### **Class I Design Review Application for 18825 Willamette Dr (DR-23-09)**

PROJECT: MATIN REAL ESTATE OFFICE TENANT IMPROVEMENT  
 18805-18837 WILLAMETTE DR  
 WEST LINN, OREGON 97068

**Supplemental Information in Response to Incomplete Notice of October 24, 2023**

# PROPOSED LANDSCAPE SITE PLAN

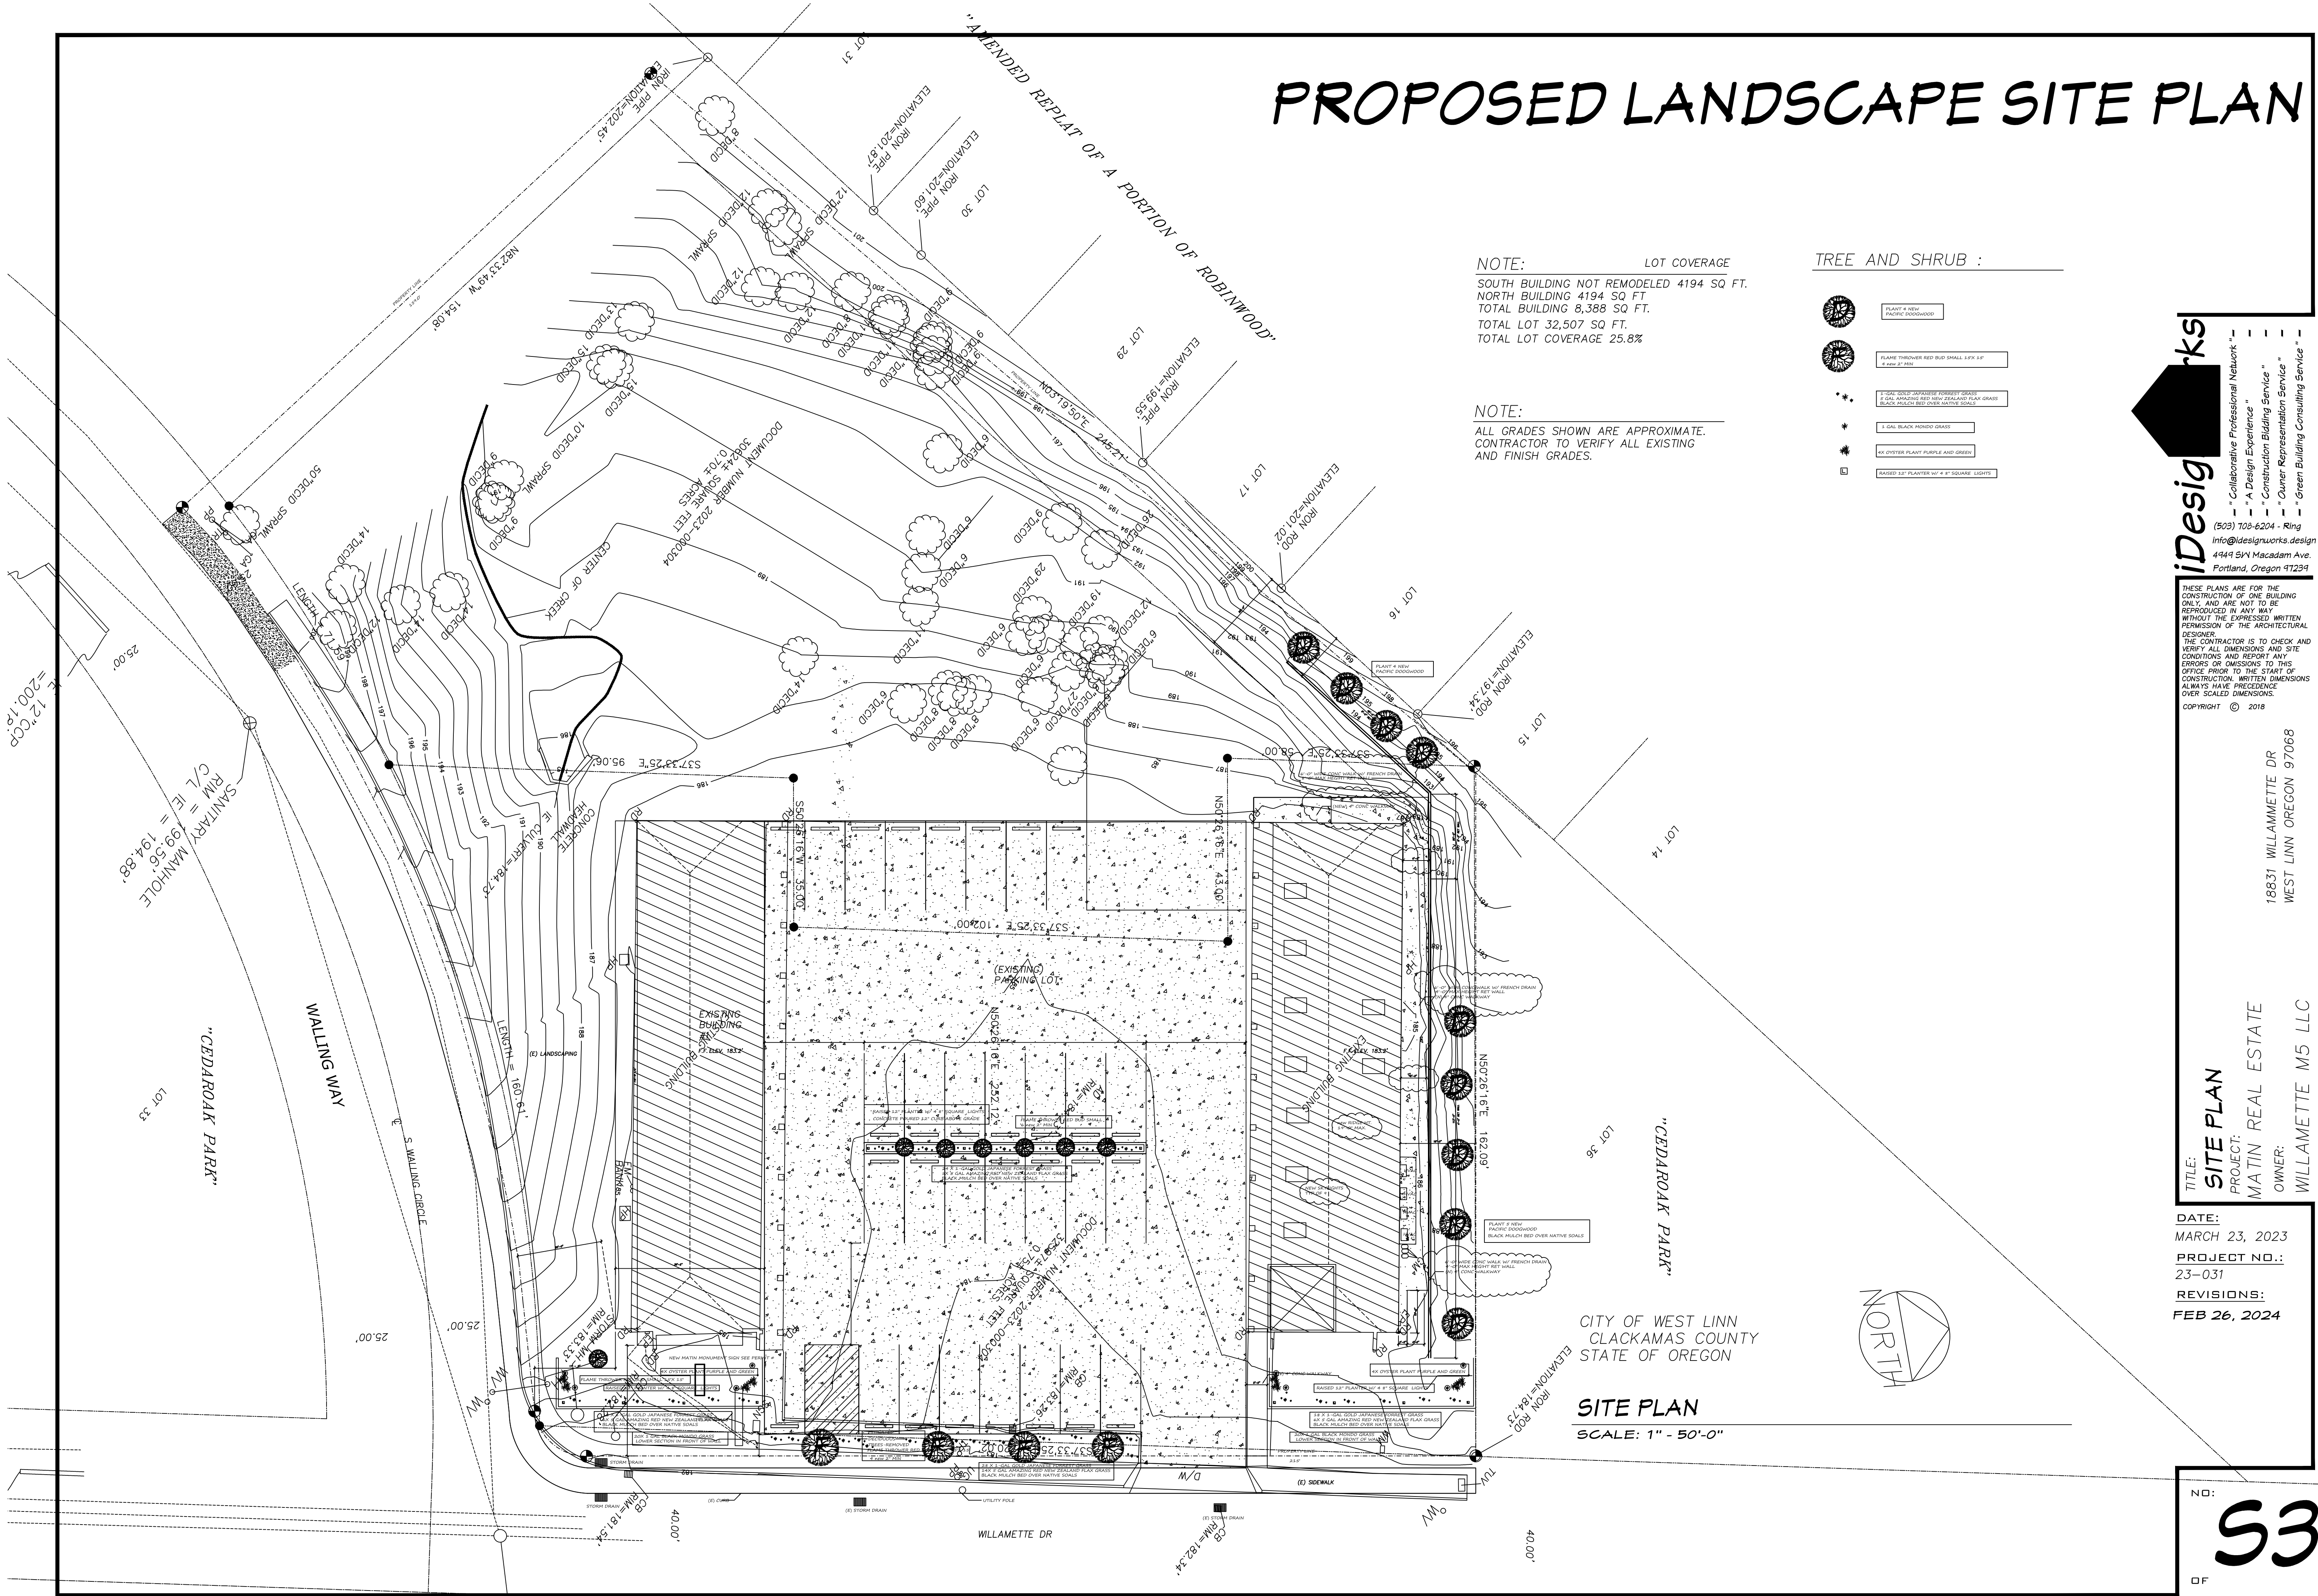
- 3) CDC 19.070(7) (GENERAL COMMERCIAL): Landscape elements in plan do not reflect current conditions or proposed conditions that meet applicable provisions (as an example, it shows landscape elements that have been since removed while also showing proposed changes). A note on the plan also states that a landscape plan is 'TBD'. Note that new street trees are required to be planted along Willamette Dr. frontage that meet the requirements of the City Arborist. They need to be shown in an updated landscape plan that meets applicable provisions of CDC 54 and 55. Submit one plan for existing conditions and one for proposed conditions that meets applicable provisions.

Response: The proposed parking space has been removed from this application.
- 6) CDC 54 (LANDSCAPING): As detailed in item #3 above, an updated landscape plan is required that meets applicable provisions of CDC 54 and 55.

*Response: The application includes 4 site plans: 1.) Original Site Survey plan. 2.) S1 – Original Site Plan "AS IS". 3.) S2 - Site plan with proposed structural remodeling. 4.) S3 - Site plan with proposed Landscape.*

Response: The details are attached as Landscape Site Plan and narrative for CDC 54 and 55 on proposed landscape.
- 7) CDC 55.090(A)(1) (DESIGN REVIEW): 55.100(B)(1) through (4) were not addressed. They apply to this application and need to be addressed.

**A** RETAINING WALL DETAIL  
**R** SCALE: 3/4" = 1'-0"

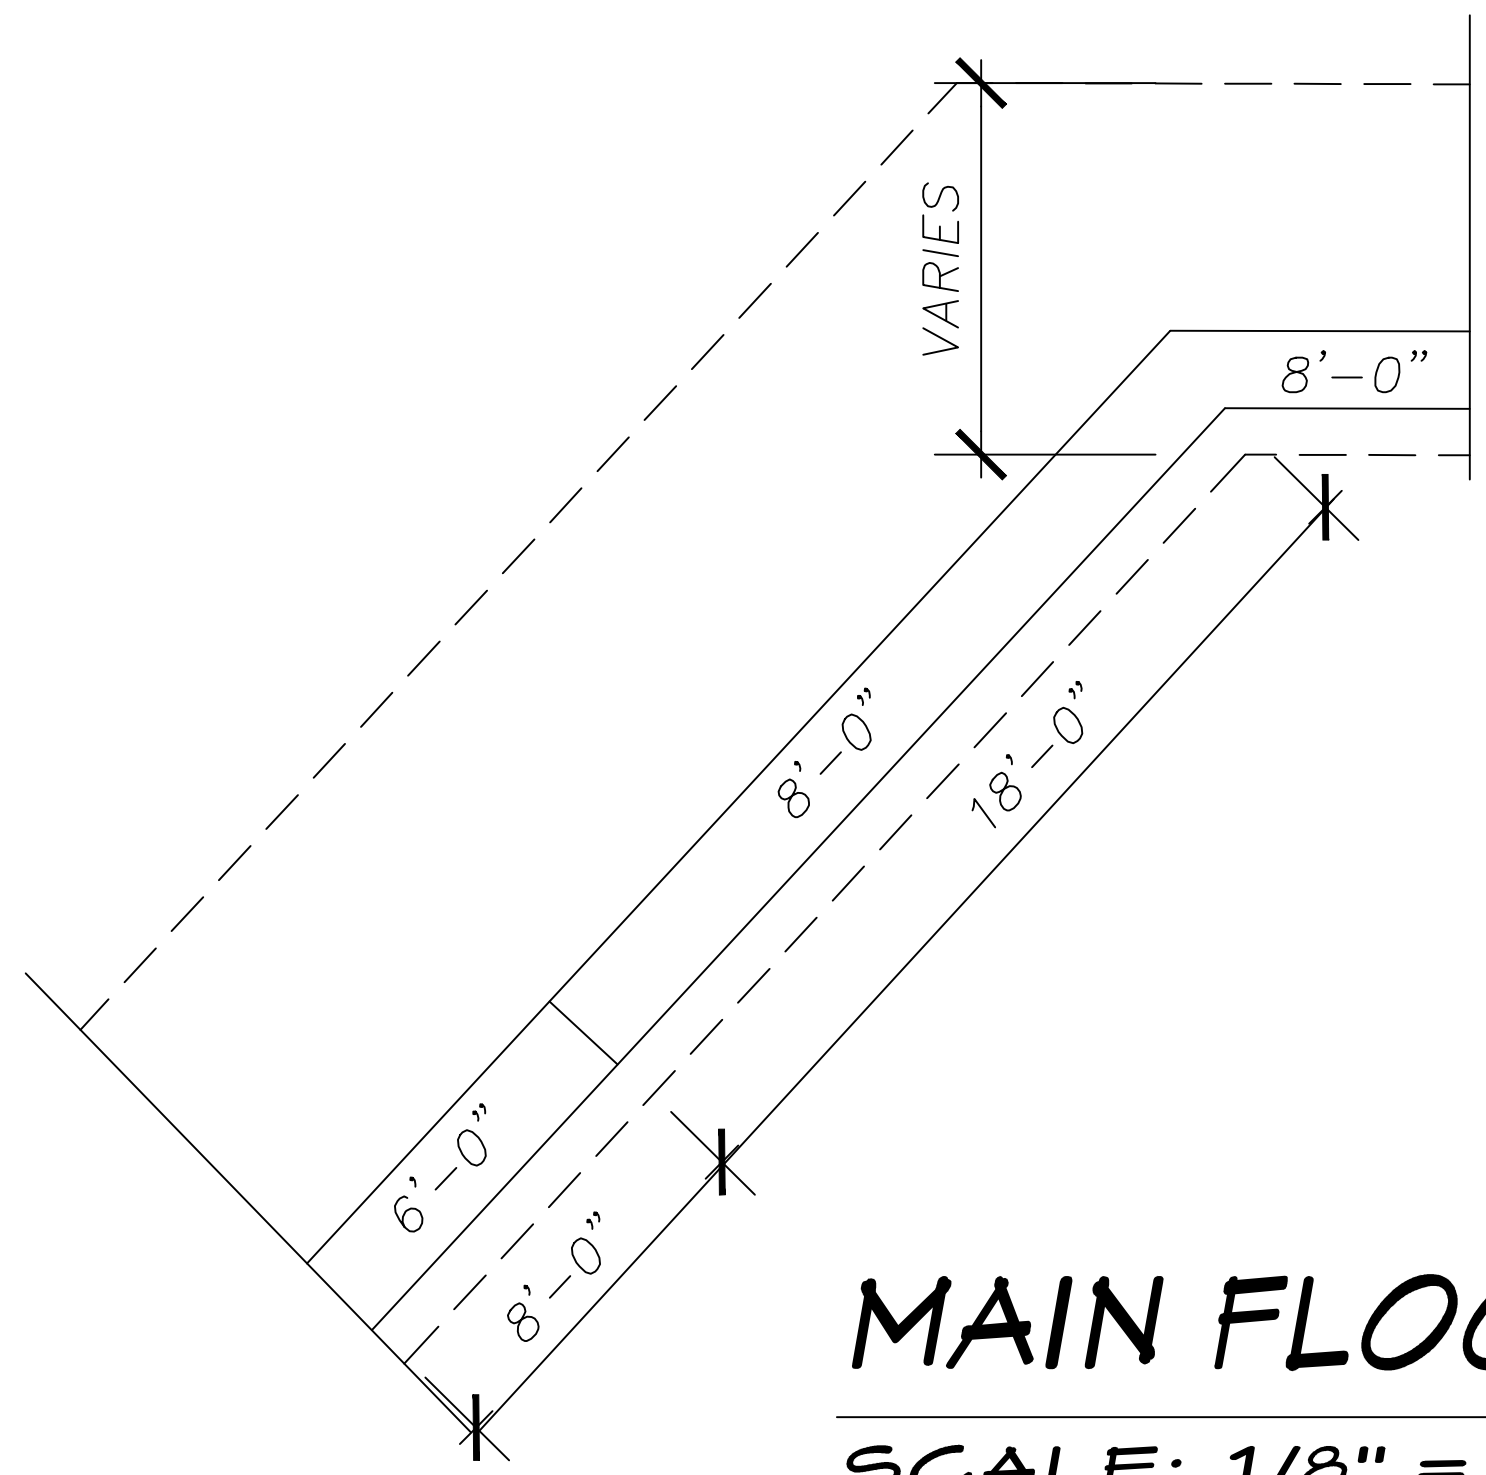
16) Provide elevations and plan view details on all proposed retaining walls as part of the required landscaping plan. These elements need to be integrated into the narrative responses to all relevant criteria within CDC 54 and CDC 55.

*Response: The retaining walls have been included in the narrative and plans.*
